Access Compliance Report

Public Rights-of-Way

(Curb Ramps)

Intersection ID: 16619	Main Street: PARK_RD	Cross Street: YALE_PL	Location: NE
ADA ID: 66BED0A33A2D	Ramp Type: PerpDiag	Initial Pass/Fail: Fail	Overall Compliance: No
Severity Score: 25			
Codes/Mitigation Info/Possible Solution		Field Measurements/Component Compliance

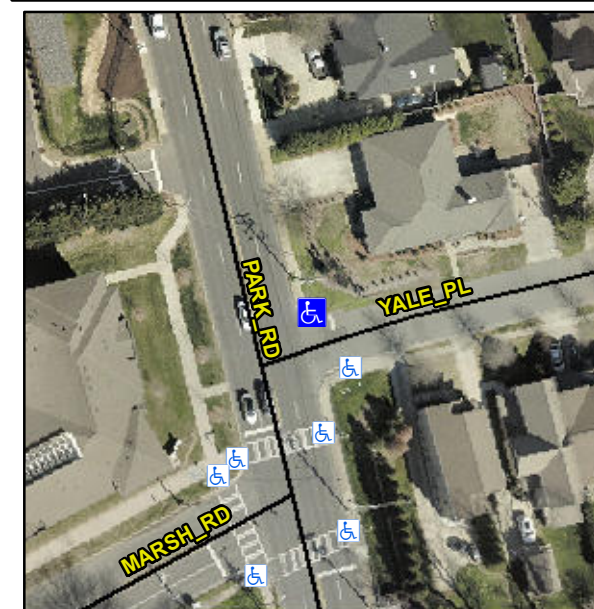
Not Found, R304.2.2, R304.5.3

Compliance	Description	Data	Compliance	Description	Data
N/A	Ramp Length (in)	59.0	No	Ramp Slope (%)	8.7
Yes	Ramp Width (in)	48.0	No	Ramp XSlope (%)	6.8
N/A	Flare Type LT	N/A	N/A	Flare Type RT	N/A
N/A	Flare Slope LT (%)	N/A	N/A	Flare Slope RT (%)	N/A
N/A	Flare Traversable LT?	N/A	N/A	Flare Traversable RT?	N/A
N/A	Landing Length (in)	N/A	N/A	DWS Provided?	N/A
N/A	Landing Width (in)	N/A	N/A	DWS Contrast?	N/A
N/A	Landing Slope (%)	N/A	N/A	DWS Length (in)	N/A
N/A	Landing X Slope (%)	N/A	N/A	DWS Full Width?	N/A
N/A	Landing Curb? (Y/N)	N/A	N/A	DWS Offset (in)	N/A
N/A	Shared Landing?	N/A			
N/A	Gutter Ponding?	N/A	N/A	Gutter Slope (%)	N/A
N/A	Gutter Lip Ht (in)	N/A	N/A	Gutter X Slope (%)	N/A
N/A	Painted X Walk1?	No	N/A	Painted X Walk2?	No
	X Walk 1 Direction	To W		X Walk 2 Direction	To S
N/A	X Walk 1 Width (in)	N/A	N/A	X Walk 2 Width (in)	N/A
	X Walk 1 Slope (%)	7.1		X Walk 2 Slope (%)	1.3
	X Walk 1 X Slope (%)	3.1		X Walk 2 X Slope (%)	2.6

N/A	Ramp inside XWalk1?	N/A	N/A	Ramp inside XWalk2?	N/A
	Road Slope (%)	4.0	N/A	Clear Space?	N/A
	Road X Slope (%)	1.3	N/A	Clear Space to XWalk (in)	N/A
N/A	Any Obstructions?	N/A	N/A	Storm Grate/Utility Hazard?	N/A
	Obstruction Type			Storm Grate/Utility Type	
		N/A			N/A
			Yes	Surface Condition? (G/P)	Good

Remove & Replace Curb Ramp With Two New Directional Ramps or Equivalent.
